APPLICATION NO.	FILING DATE	FIRST NAMED INVENTOR	ATTORNEY DOCKET NO.	CONFIRMATION NO.
10/712,974	11/13/2003	Bernhard Jakob	964-031963	7350
28289	7590	09/25/2007		
THE WEBB LAW FIRM, P.C. 700 KOPPERS BUILDING 436 SEVENTH AVENUE PITTSBURGH, PA 15219			EXAMINER CIRIC, LJILJANA V	
			ART UNIT	PAPER NUMBER
			3744	
			MAIL DATE	DELIVERY MODE
			09/25/2007	PAPER

Office Action Summary

DETAILED ACTION

Figure 2a (Prior Art)

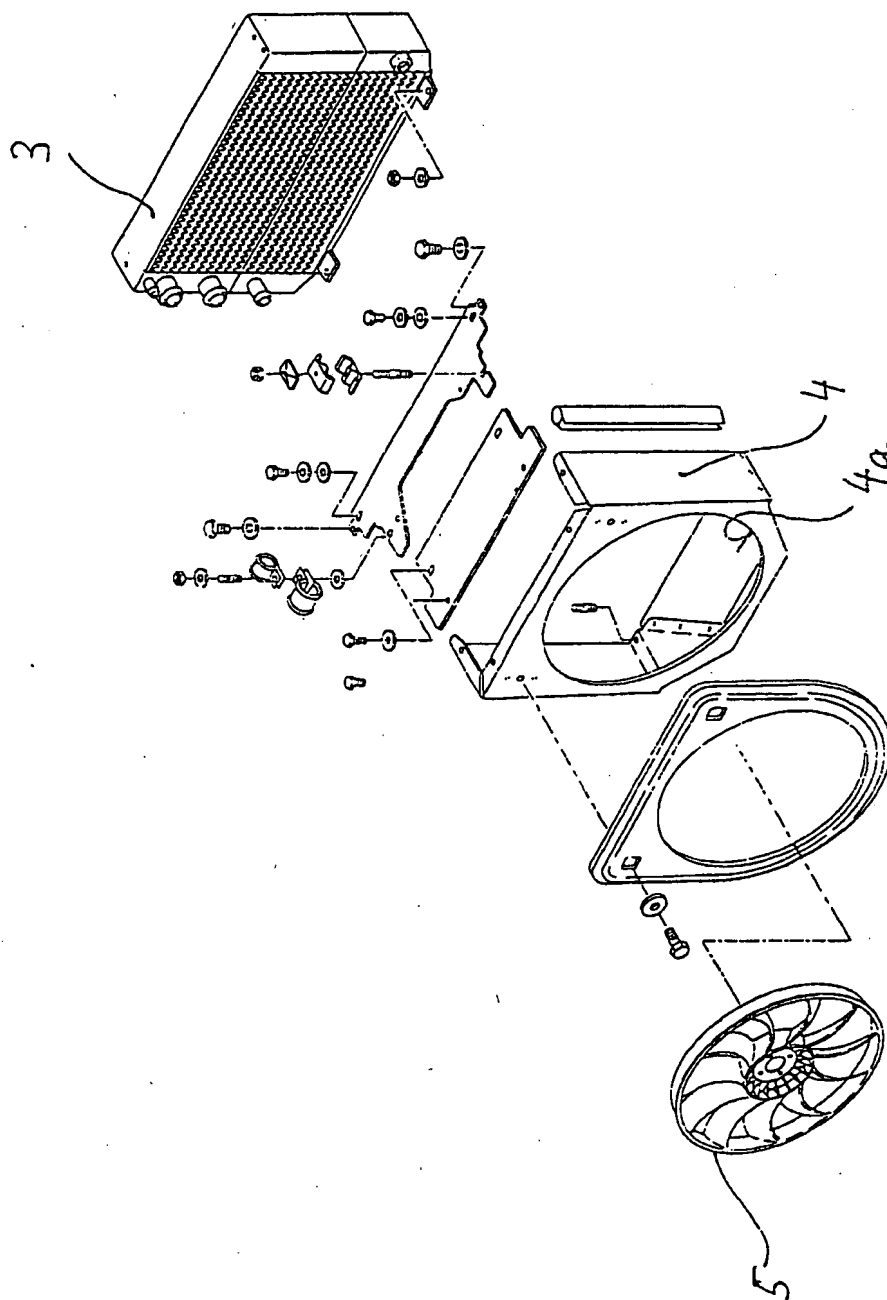
5. The replacement drawings received on October 23, 2006 are objected to because the line quality of the drawings is generally poor. Corrected drawing sheets in compliance with 37 CFR 1.121(d) are required in reply to the Office action to avoid abandonment of the application. Any amended replacement drawing sheet should include all of the figures appearing on the immediate prior version of the sheet, even if only one figure is being amended. The figure or figure number of an amended drawing should not be labeled as "amended." If a drawing figure is to be canceled, the appropriate figure must be removed from the replacement sheet, and where necessary, the remaining figures must be renumbered and appropriate changes made to the brief description of the several views of the drawings for consistency. Additional replacement sheets may be necessary to show the renumbering of the remaining figures. Each drawing

6. The replacement drawings received on October 23, 2006 are objected to under 37 CFR 1.83(a). The drawings must show every feature of the invention specified in the claims. Therefore, the following features must be shown or the features canceled from the claims: the wiper being "realized in the form of a brush" as recited in claims 4 and 9. Applicant's argument that it is believed that Figure 3 shows wiper 9 in the form of a brush as recited in claims 4 and 9 because bristle protrusions are shown; however, the aforementioned argument by applicant is not found persuasive because the line quality of the drawings (both the original drawings and the replacement drawings) is too poor to provide clear support for the applicant's argument. No new matter should be entered.

not approved.
LVC
1-7-07

Figure 1

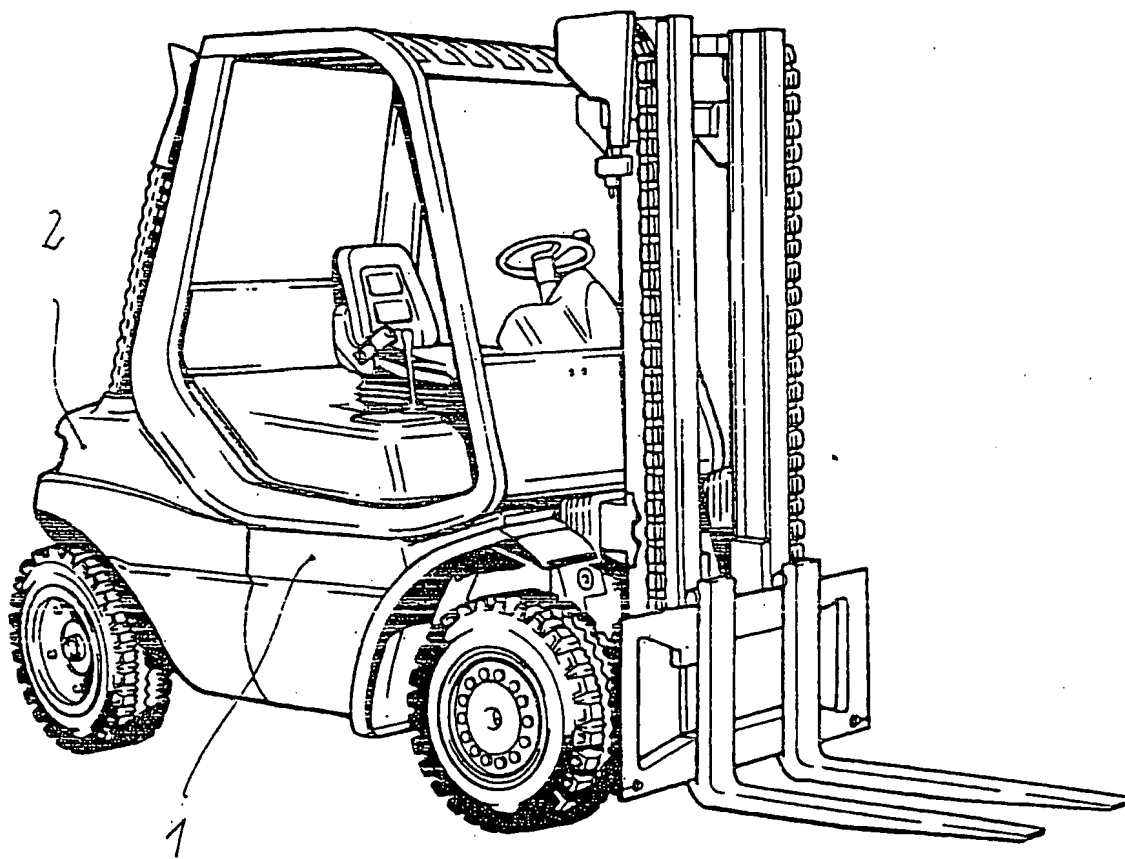
Not approved
sic
1-7-07

Figure 2C (Prior Art)

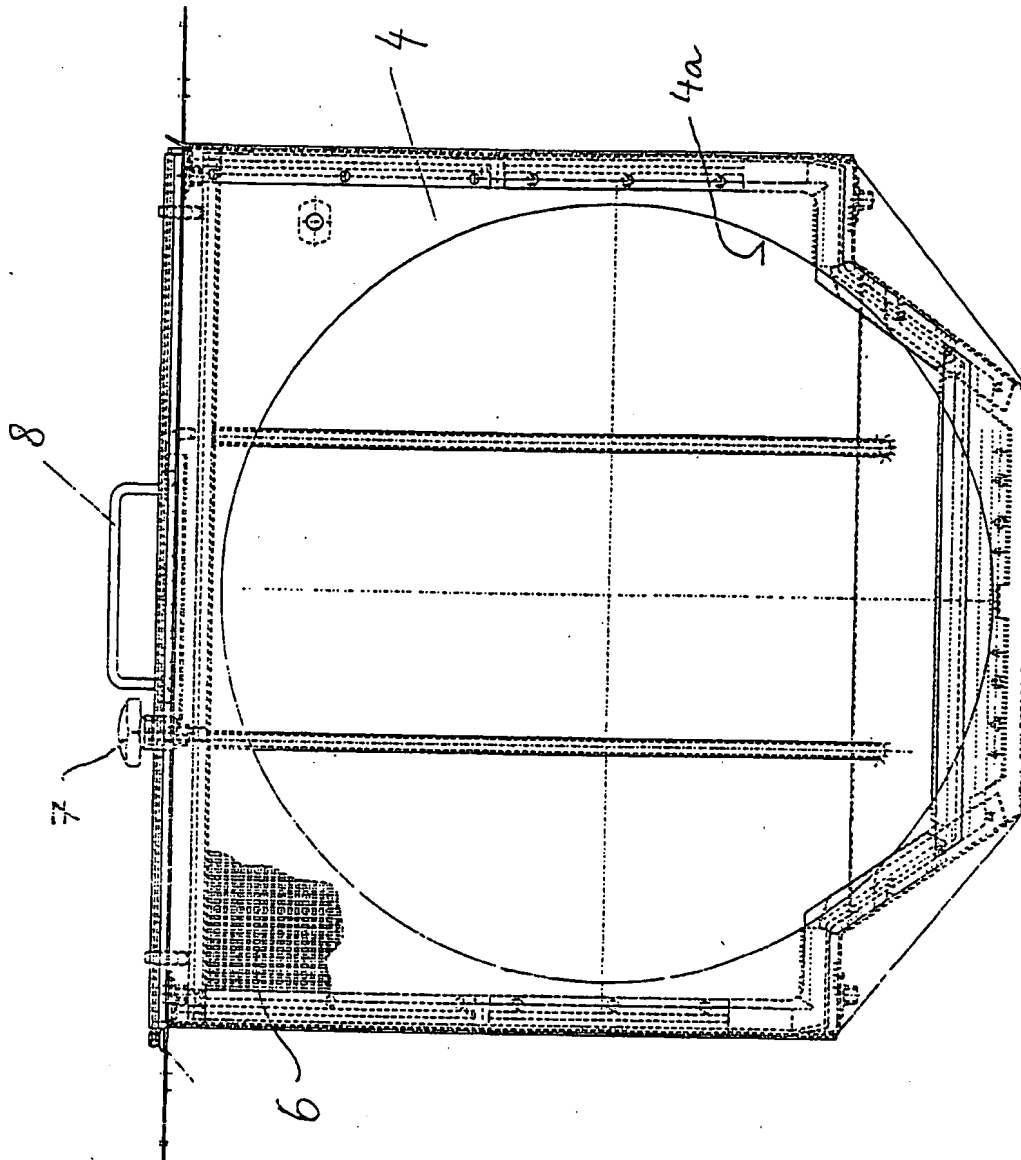
Not approved.
LRC
1-7-07

Figure 3

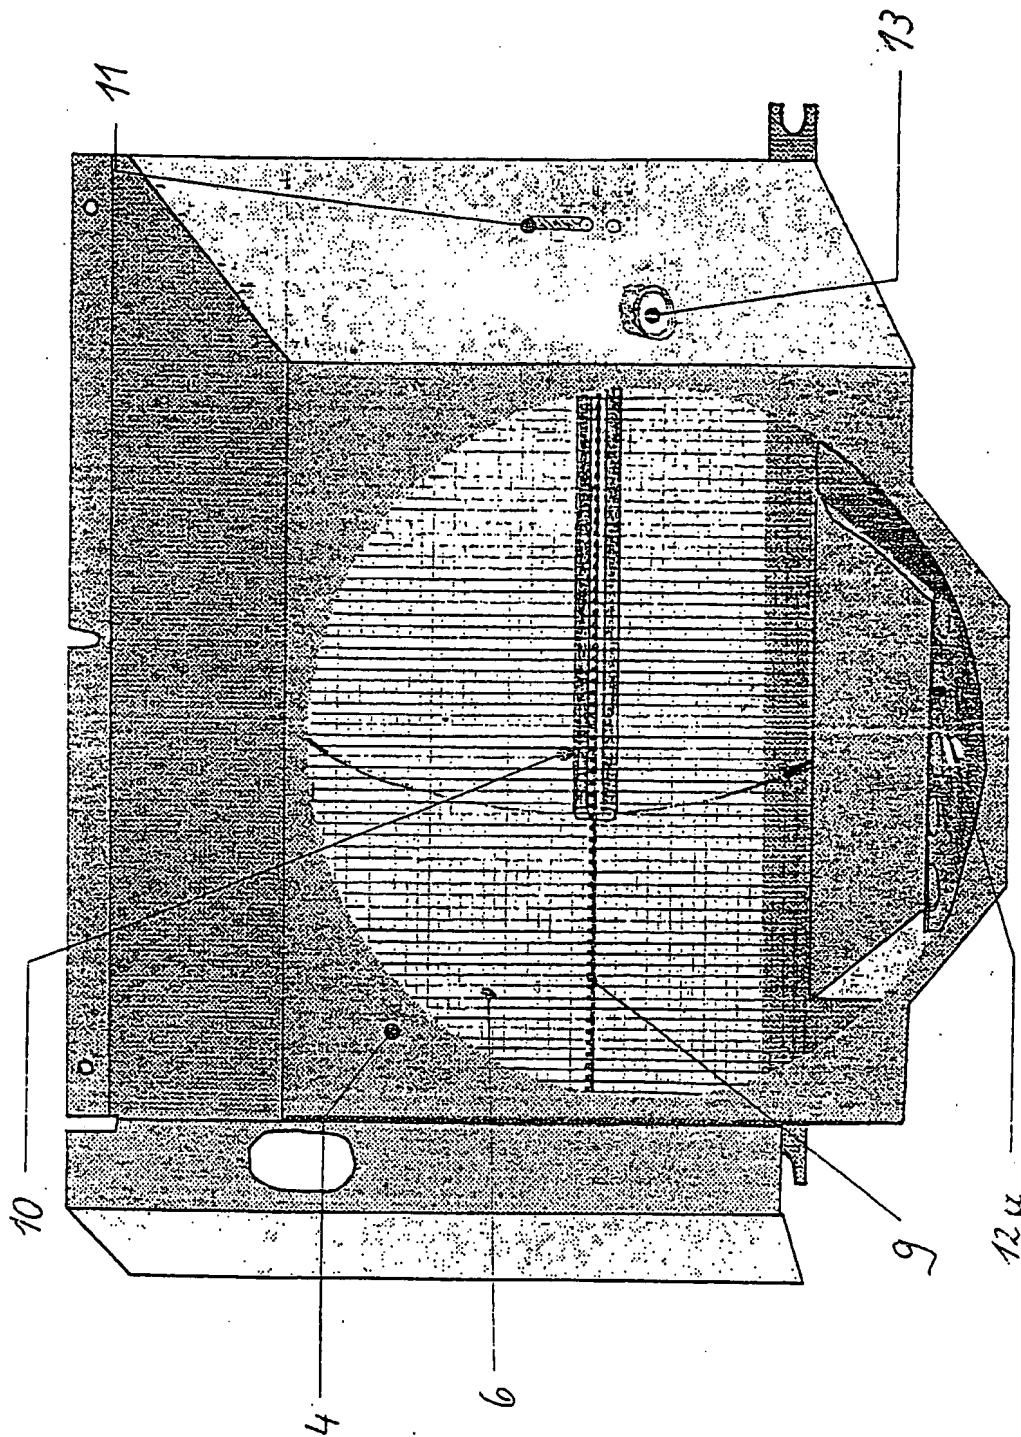
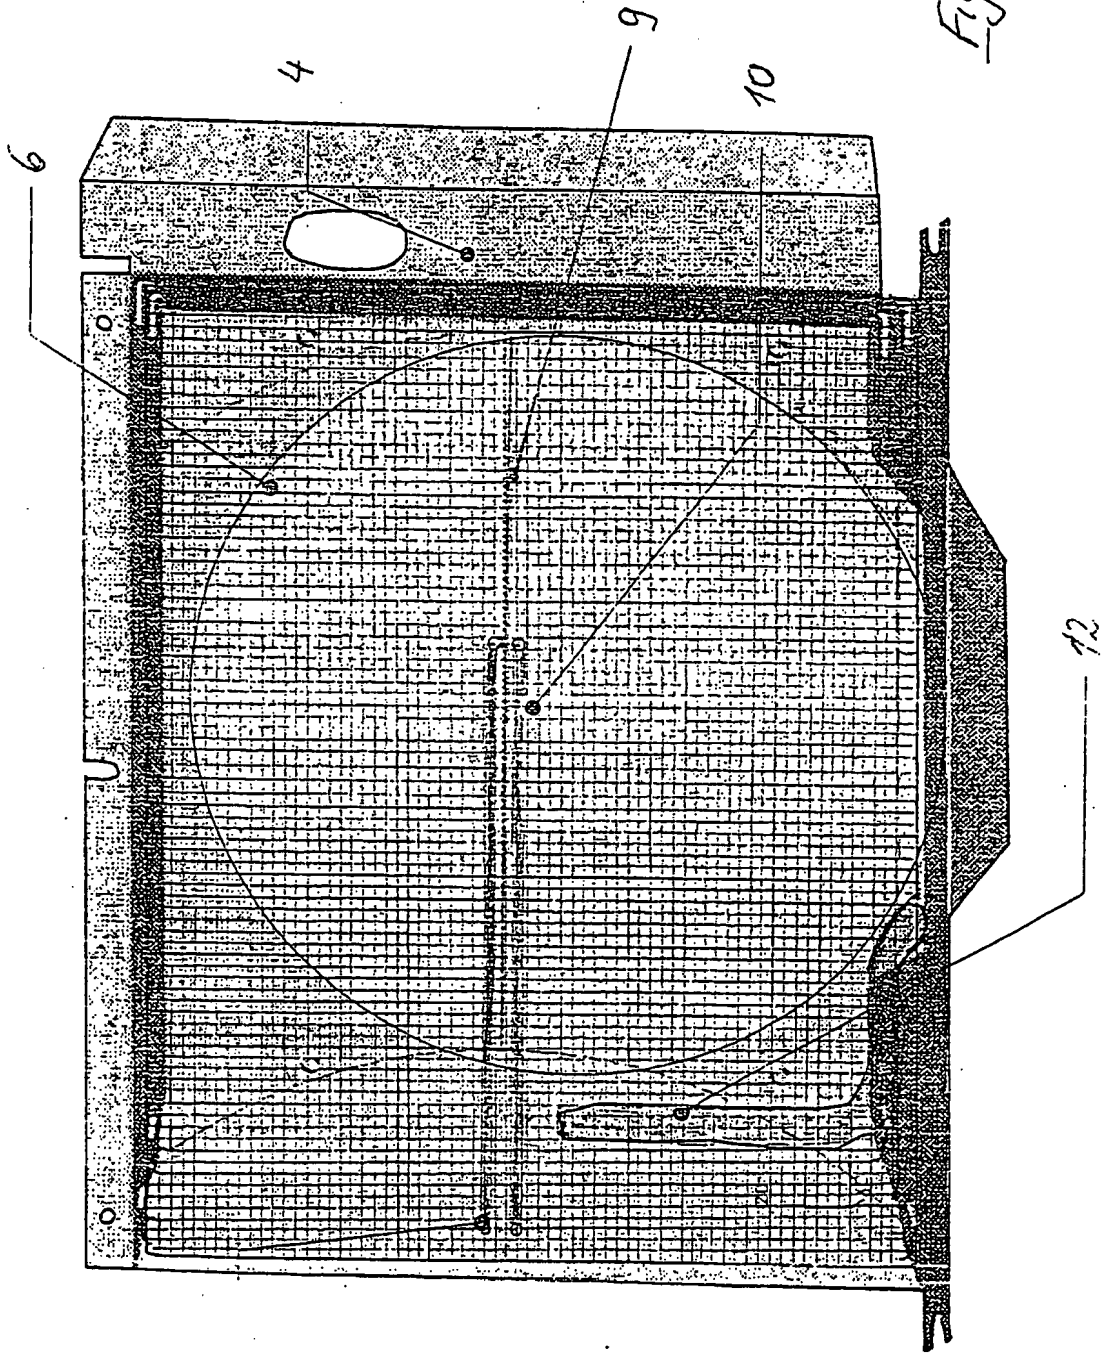
Not approved.
LVC
1-7-07
